APPLICATION NO.	FILING DATE	FIRST NAMED INVENTOR	ATTORNEY DOCKET NO.	CONFIRMATION NO.
09/480,588	01/10/2000	ROBERT LEONARD FULKS	9D-HR-19163-	4504
7590...	08/26/2004			EXAMINER JEFFERY, JOHN A
John S. Beulick Armstrong Teasdale LLP One Metropolitan Square, Suite 2600 St. Louis, MO 63102			ART UNIT 3742	PAPER NUMBER
DATE MAILED: 08/26/2004

Office Action Summary	Application No.	Applicant(s)	
	09/480,588	FULKS, ROBERT LEONARD	
	Examiner	Art Unit	
	John A. Jeffery	3742

DETAILED ACTION

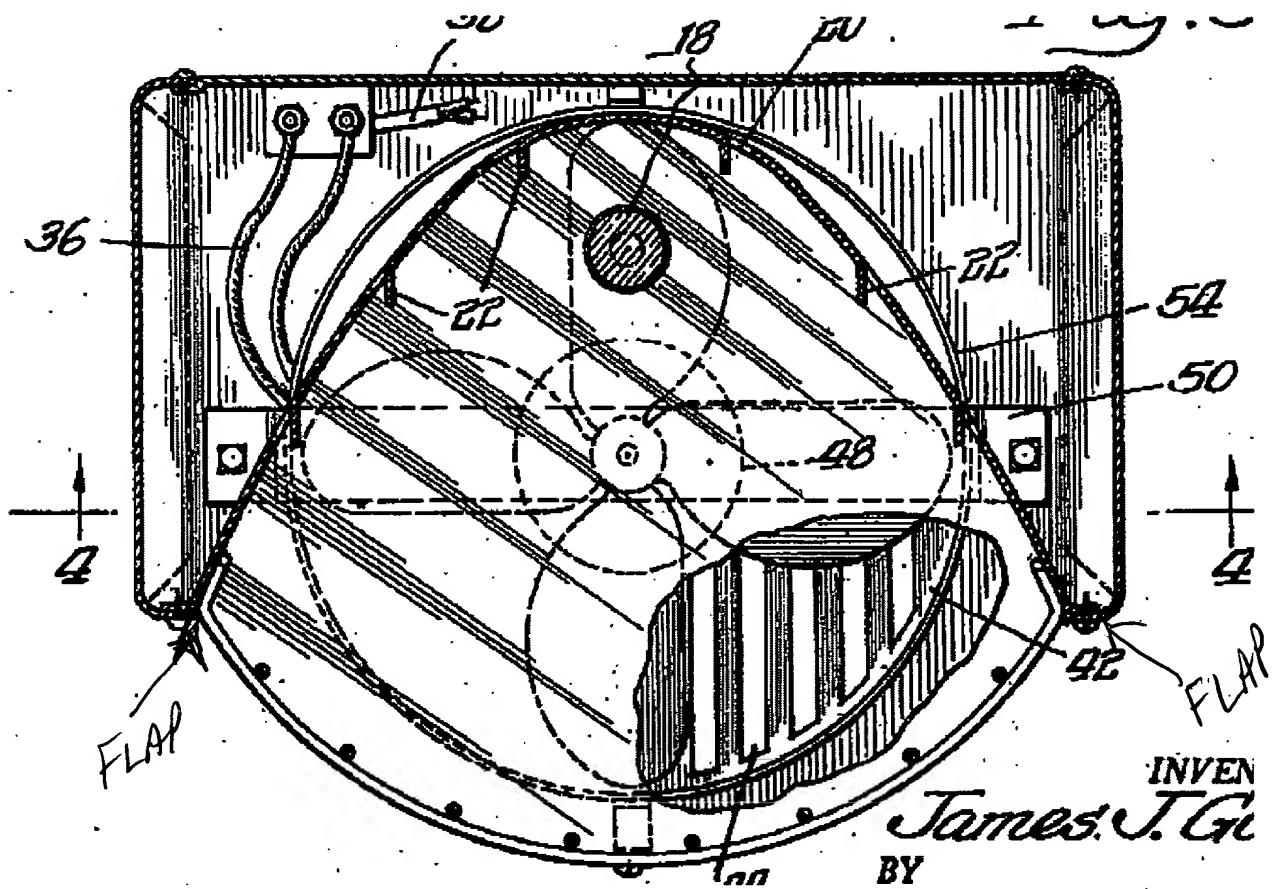
Claims 1-8, 10, 11, and 13-16 are rejected under 35 USC 102(b) as being anticipated by Gough (US 2,410,211). The scope and breadth of the claim language did not preclude the citation of Gough (US 2,410,211) who discloses a reflective "bracket" 14 comprising a parabolic channel with longitudinal ventilation openings 20. See Figs. 1-3. Each ventilation opening has a "shield" 22 integral with the channel. Lateral openings 26 extend along opposite sides of the channel. Regarding claim 7, note the unlabeled "flap" extending from the channel sides as indicated on an enlarged reproduction of Fig. 3 of Gough (US 2,410,211) below.

Also, regarding claim 15, "holding bracket" 24 extends from the channel and comprises a plurality of "fingers" 28.
